STAFF REPORT

AGENDA ITEM: **Zoning Code Text Amendment, Final Plat and Planned Unit Development (PUD) Plans and Conditional Use Permit for Motor Vehicle Sales and Rental Facility**

City Engineer Review. The City Engineer prepared a final plat review memo (dated August 2, 2021) and a site plan/construction review memo (dated August 2, 2021) related to these requests. I have attached these memos for your reference. The following is a summary of his review comments:

UTILITY PLAN

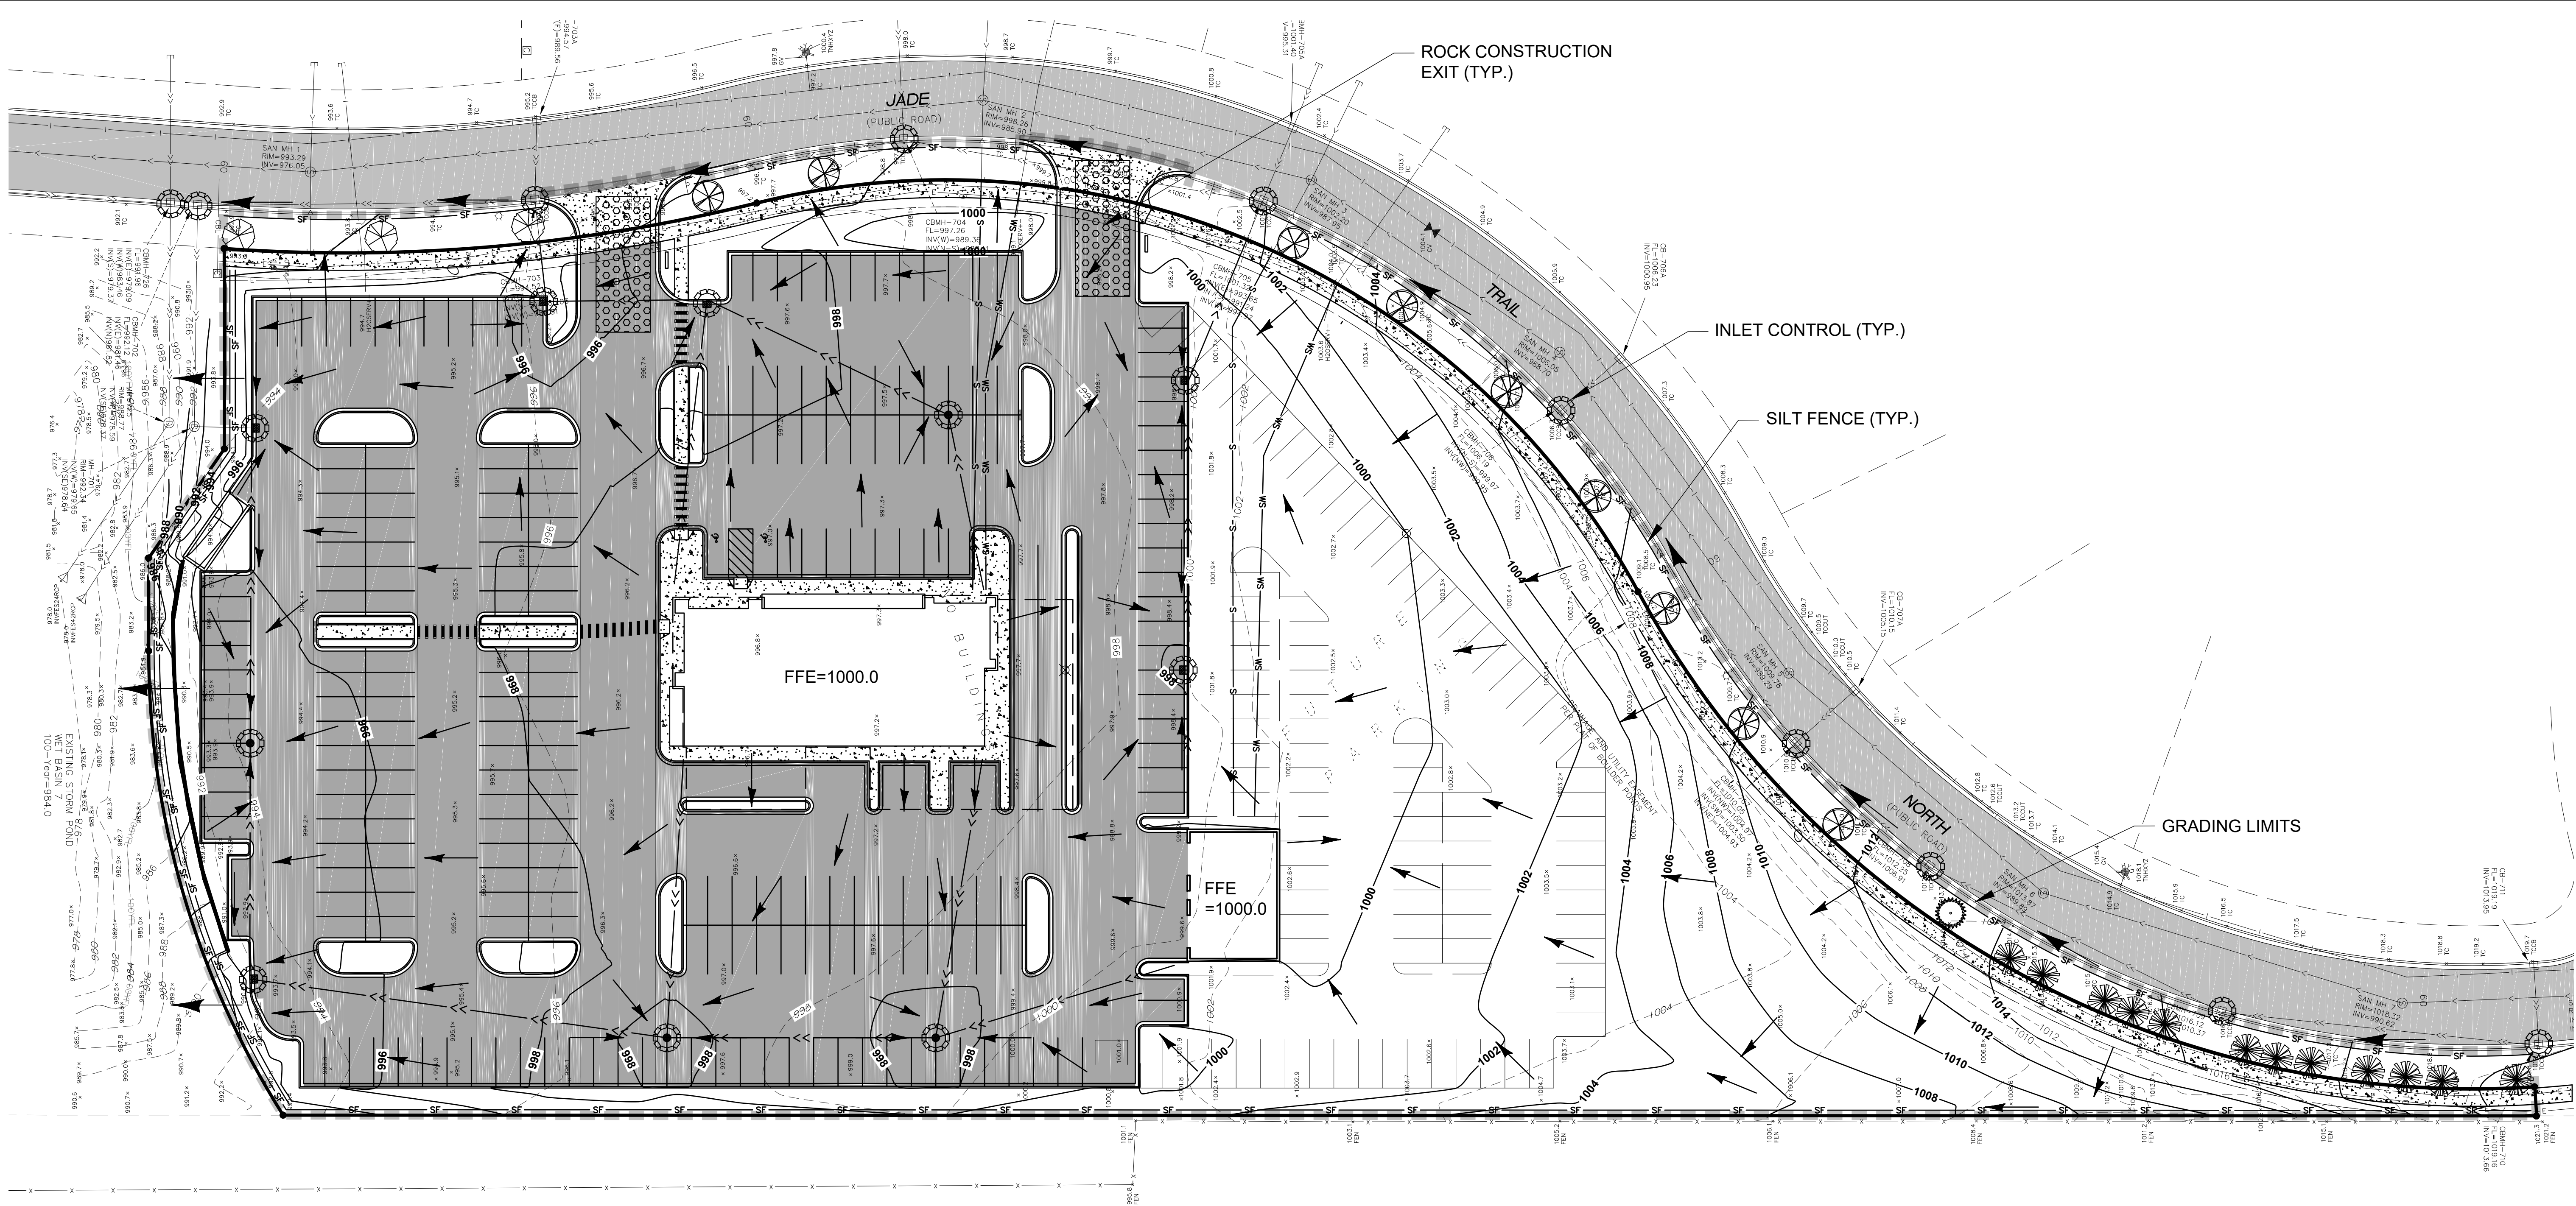
- No new fire hydrants have been proposed. There is one existing fire hydrant located along Jade trail about 220 feet from the proposed office building. If fire hydrant(s) are required interior to the site as may be required by the Lake Elmo Fire Department, the fire hydrants and connecting water main will be City owned and maintained. If required, the applicant must revise and resubmit the and project specifications for City review, showing the proposed hydrant(s) and connecting watermain using City design standards, details and specifications. Utility easements must be dedicated to the City that are at least 30-feet wide centered over the pipe and hydrants, and all easements must be shown on appropriate plans and on the final plat. **Note:** The Fire Department and the City Engineer have determined that the applicant will need to install a fire hydrant near the northwest corner of the building so the applicant will need to revise the project plans to show this hydrant and the watermain serving it.

- Connection to existing watermain stubs. The project proposes to connect to existing 6-inch watermain service stubs located along Jade Trail, one connection for each building. The water services interior to the site will be private services and must meet state building code requirements unless hydrants are required to be place interior to the site. The plans also must be revised to change the service pipe materials to meet City standards.

- 3) The applicant revise all project plans to address the review comments of the City Engineer in his memos dated August 2, 2021.
- 4) The applicant shall revise the project plans to show a fire hydrant near the northwest corner of the building at the direction of the Fire Department and the City Engineer. All fire hydrants shall be owned and maintained by the City.

1 LANDSCAPE PLAN
SCALE= 1" = 30'-0"

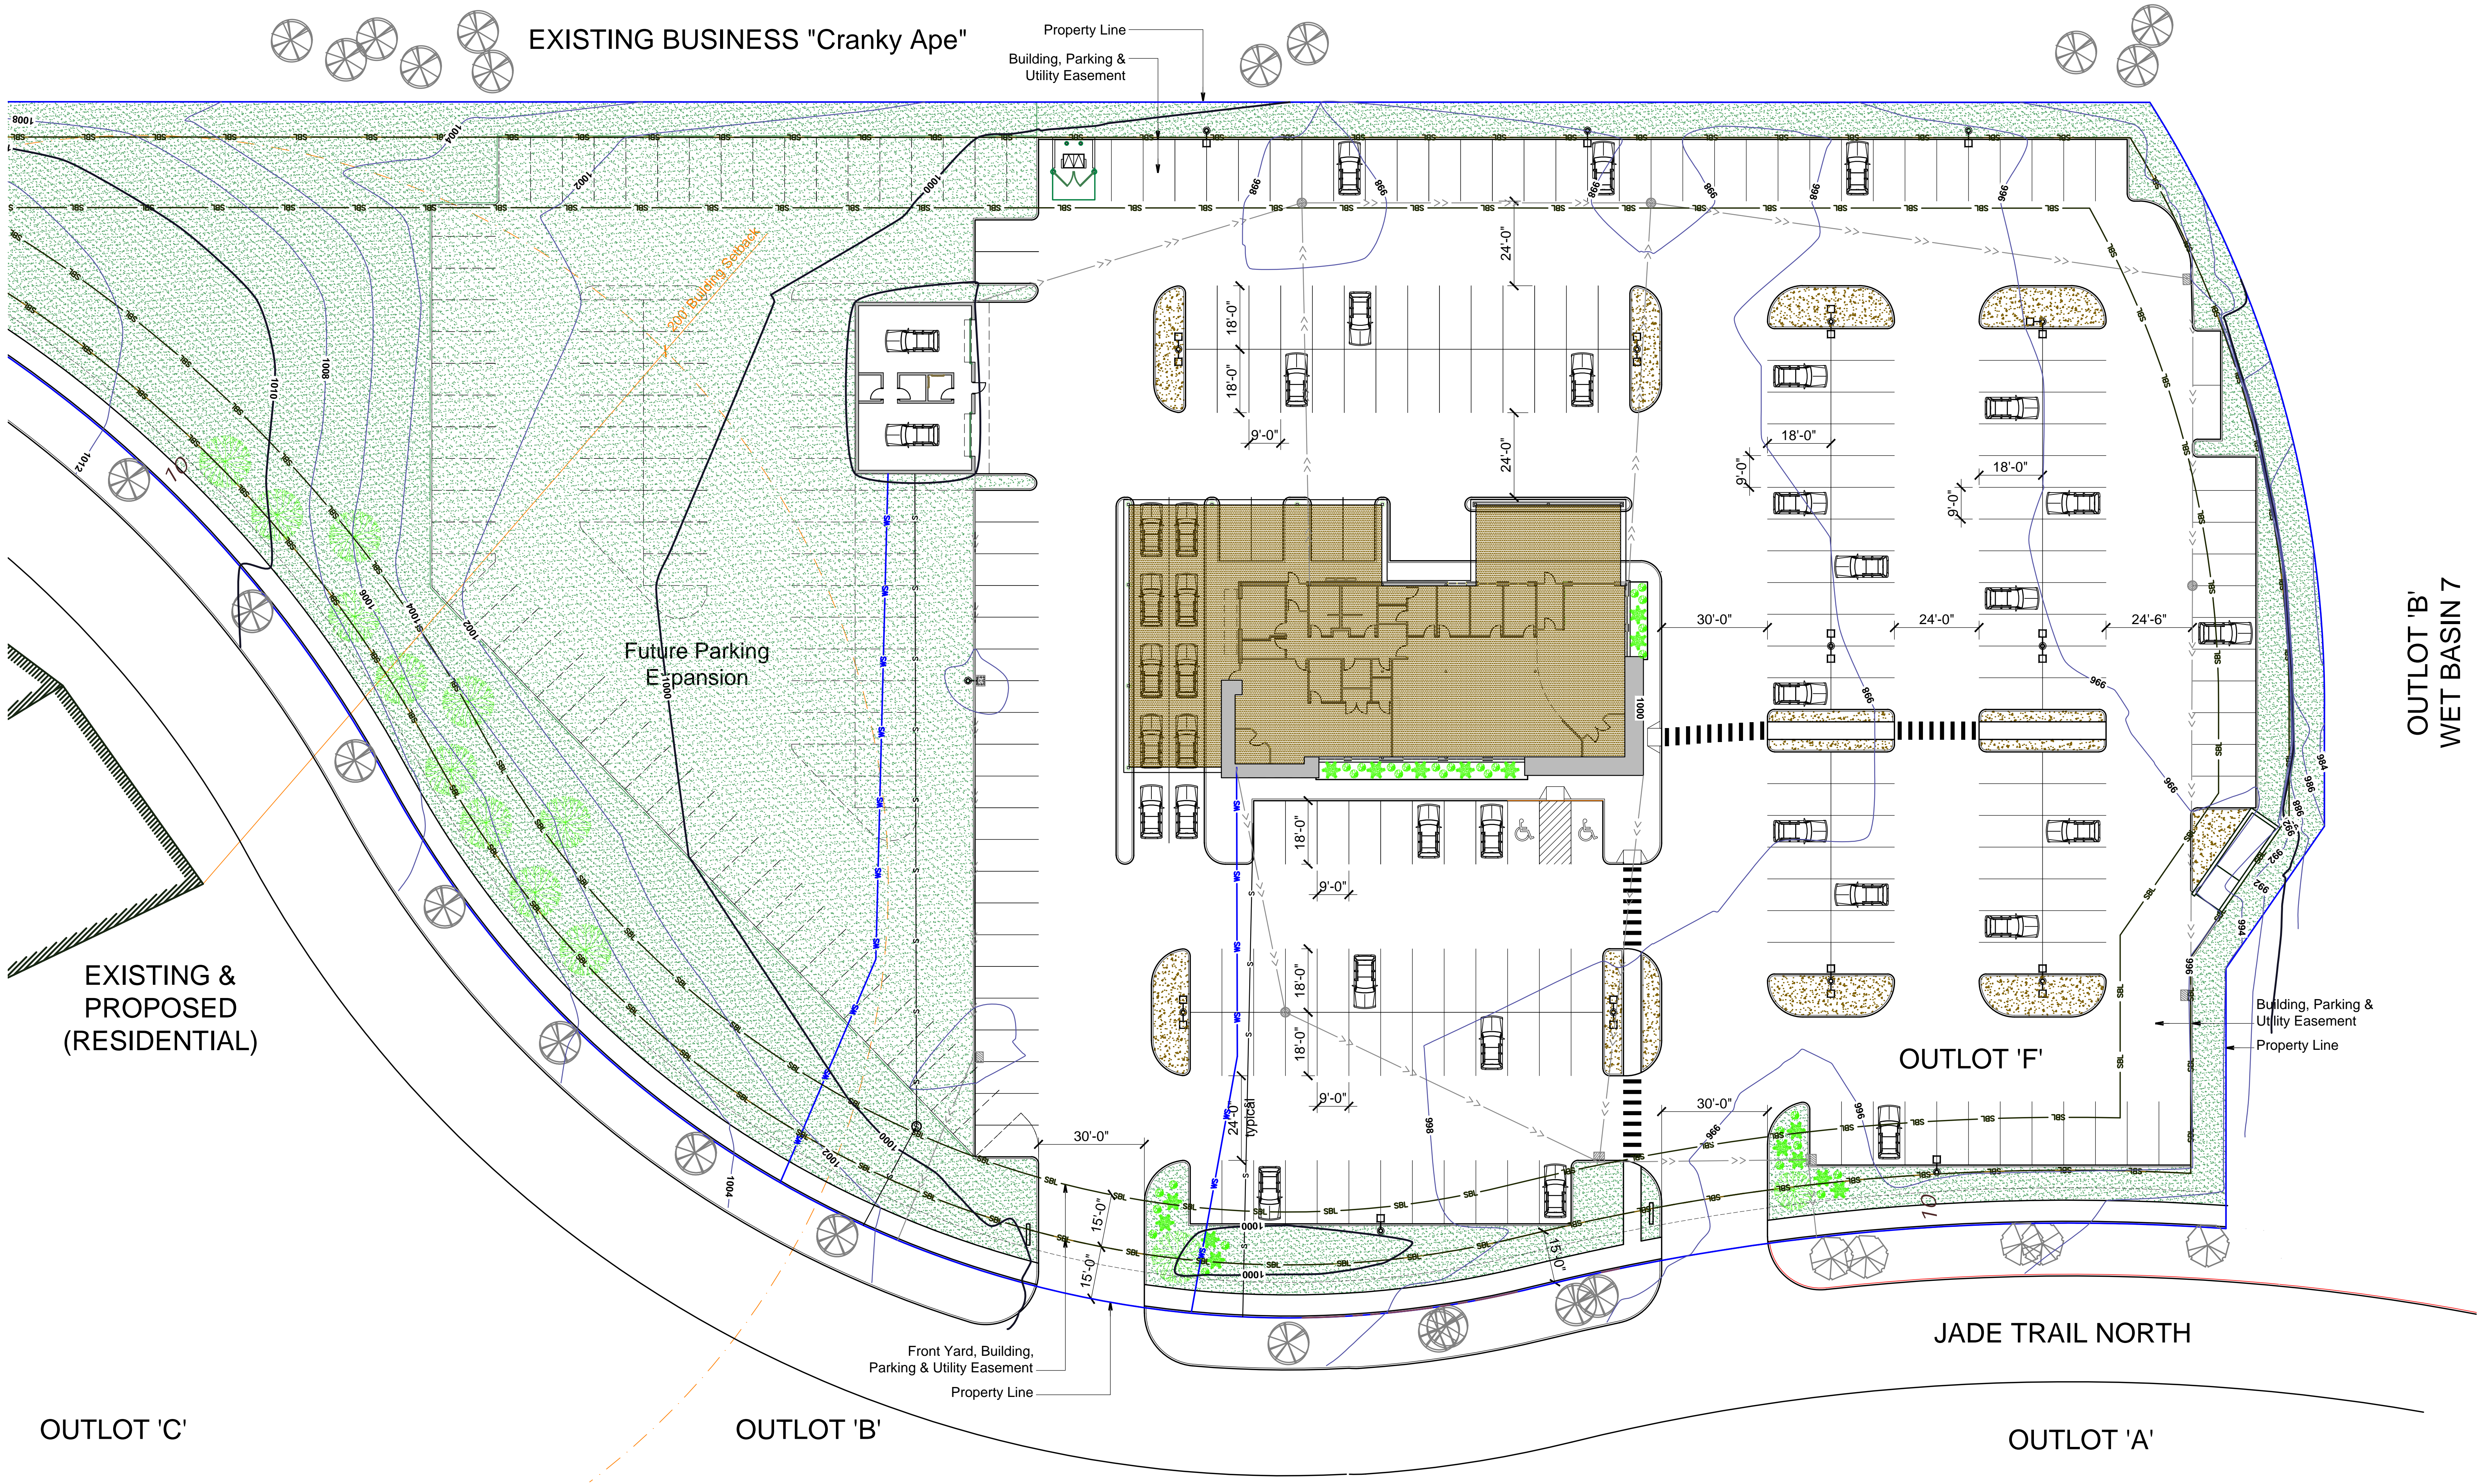
- The submitted landscape plan does not include the required number of trees, as 75 are required, and 43 are proposed.
- Screening is required at the northern and western edge of the parcel due to the parcel to the across Jade Trail being of a less intense use.
- Ground cover material specifications are not included.
- The proposed landscape plan does not include required City standard notes and details.
- All utilities are not shown on the landscape plan to review for tree placement conflicts. All utility conflicts will need to be corrected.
- The plan does not include a quantity of shade trees to meet the interior parking lot planting requirements per the City Code.

21. L100. Add city standard plan notes for landscaping, including requirement to field stake for city review prior to planting trees, and to place boulevard trees per city standard detail 805.

- 5) Landscape plans must be revised and approved by the City's Landscape Architect prior to recording of the final plat. The landscape plans must meet all City parking lot landscaping and screening requirements including screening on the northern portion of the property from adjacent properties and the public right-of-way.
